CENTURY CITY AREA TUNNELING SAFETY AND FAULT INVESTIGATIONS

Tunnel Advisory Panel (TAP)

Los Angeles County Metropolitan Transportation Authority

October 14, 2011

Figure 1: Schematic Cross Section of Santa Monica Fault Zone (from Figure 5, *Century City Area Fault Investigation Report*)

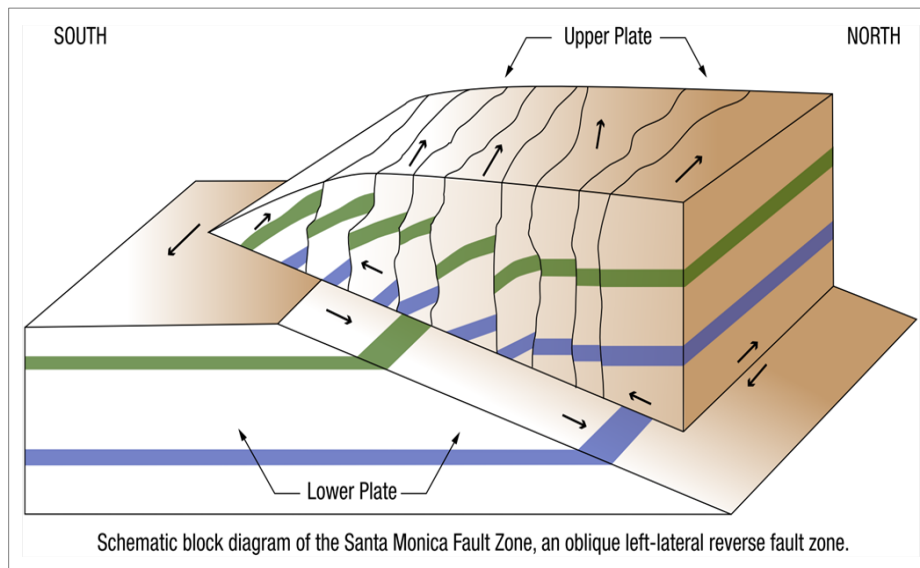
The deformation characteristics of the fault are schematically illustrated by Figure 1, which shows the horizontal displacement and heave and disturbance at and behind the front of such a thrust fault and the displacements on the strike-slip faults.

In order to maintain a Century City station alternative on Santa Monica Boulevard, the originally proposed station location was shifted to the east, roughly centered on Century Park East, in an effort to clear the Santa Monica Fault Zone.

Figure 4: Directionally Drilled Borehole along Tunnel Alignment

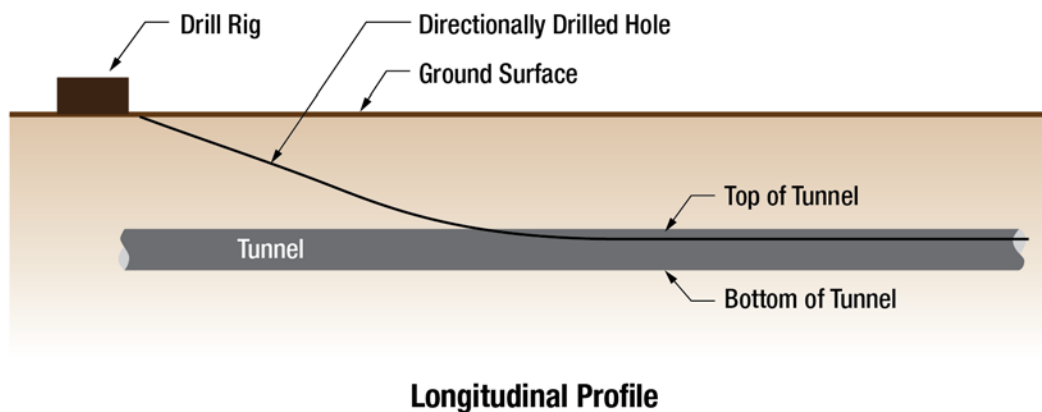
In areas of suspected abandoned wells, probing at the tunnel level is recommended to locate potential well casings before intercepting them in the tunnel. Magnetometer probe holes have been performed on past tunneling projects in Los Angeles. Magnetometer probe holes were extended in front of advancing tunneling machines in selected locations where abandoned wells were suspected to be present. Alternatively, the magnetometer probing can be accomplished prior to tunneling by using horizontal directional drilling (HDD) to extend a boring along the tunnel line into which a probe can be inserted in order to detect any steel casings in the path of the tunnels, as shown in Figure 4. If a well is encountered, procedures for removing the well casing and abandoning the well would be carried out, either prior to tunneling, or ahead of the tunnel face.

6. Conduct magnetometer surveys in probe holes drilled along the tunnel alignment in oil fields where there is the possibility of intersecting well casings, either ahead of the advancing tunnels or prior to tunneling, using horizontal directional drilling. It is recommended that, to the east of the Constellation Station and on the Beverly Hills High School property, the surveys be conducted during the design phase using horizontal directional drill holes.
